## EXHIBIT 2 - RATE BASE INTERROGATORIES

### OEB STAFF

Figure 5.3-9 Health Index Summary

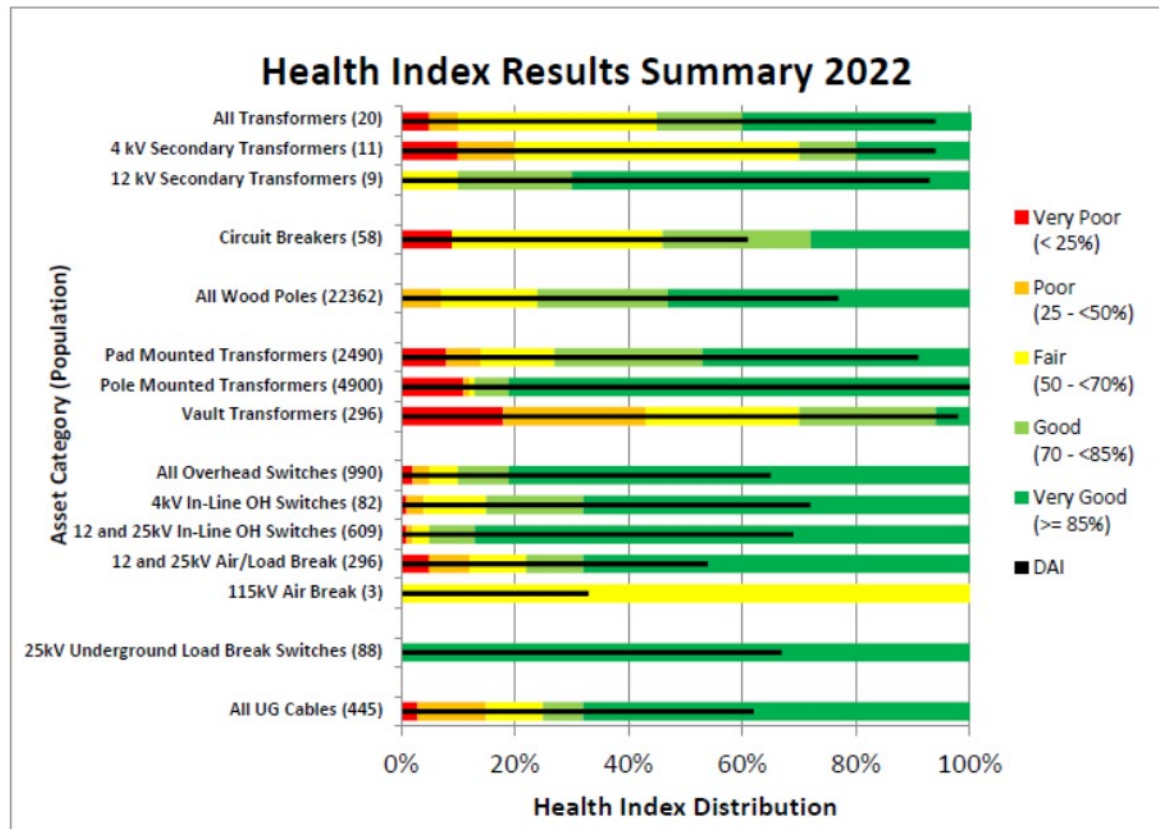
Please provide a version of Figure 5.3.9 in tabular format that shows for each asset category, the number of assets, and the percentage of those assets in each asset condition category. Please provide the information in Excel format.
